APPENDIX C
RESPONSES TO LONG SUBMISSIONS

Re: Additional Information submitted to the Department of Environmental Affairs (DEA), New Micro-Sited Layout and Inclusion of a New Listed Activity for the Proposed Caledon Wind Farm

RESPONSE TO YOUR COMMENTS SUBMITTED ON THE ADDITIONAL INFORMATION SUBMITTED TO THE DEA FOR THE CALEDON WIND FARM DATED 07 DECEMBER 2012

ADDITIONAL COMMENT ON FINAL EIA REPORT

Figure 1: Part of Overberg showing 4 potential Wind Farms

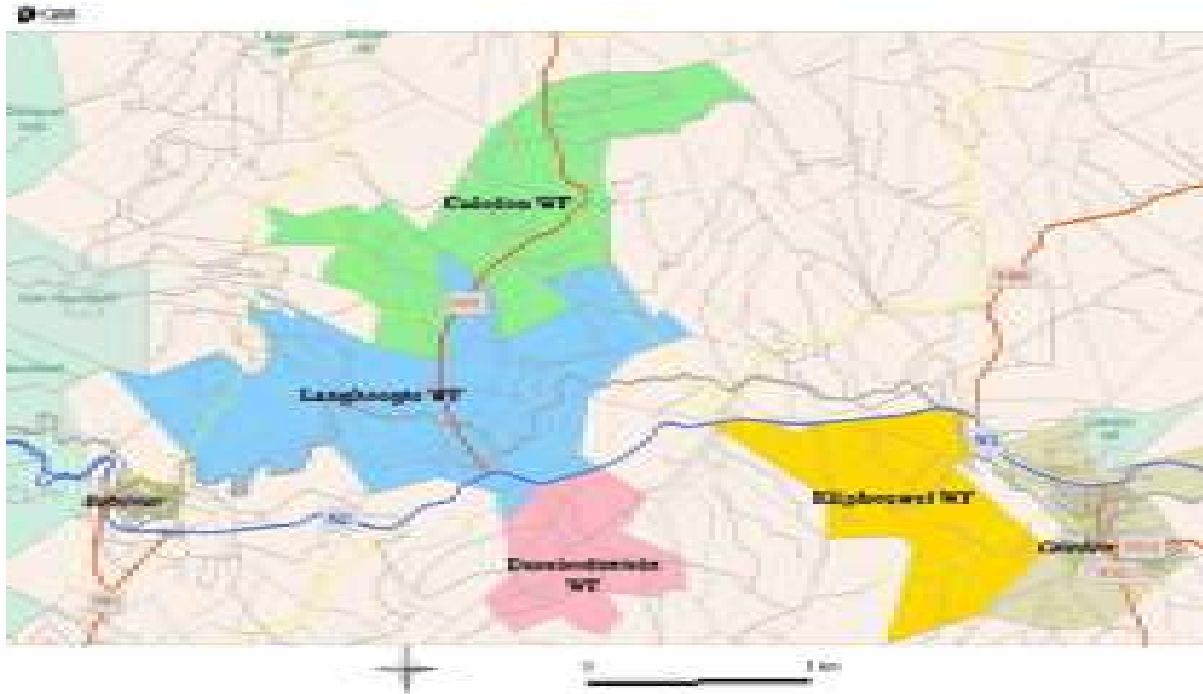
These impacts would be compounded by the development of more than one Wind Farm in the area. Of specific concern is the cumulative impact on the landscape around the N2 corridor and R43. Based on the findings of the VIA and SIA the establishment of more than one, large Wind Farm in the area was *therefore not supported* and the recent reduction to 31 turbines has produced no significant improvements.
